Instrument Engineering Change Notice

NO. Prisma-2103

Title: Addition of Alternative 20-Slide Basket

Left: alternative basket
Right: current basket

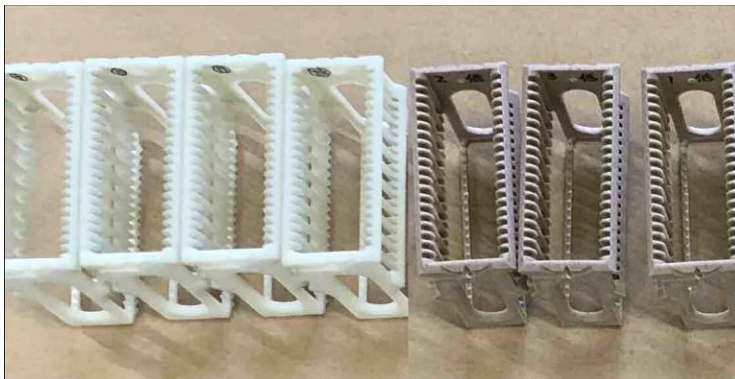
Due to difficulty in procuring base material for the current 20-slide baskets (4768), the manufacturer decided to use the alternative material (RENATUS®). With this change, the basket color is changed to white.

The quality and performance of alternative 20-slide baskets were proved equal to the current 20-slide baskets through evaluation testing by the manufacturer. The alternative basket is planned to be supplied from the beginning of the year 2022.

However, note that the change is just a temporary expedient until the current base material can be obtained sufficiently and stably.
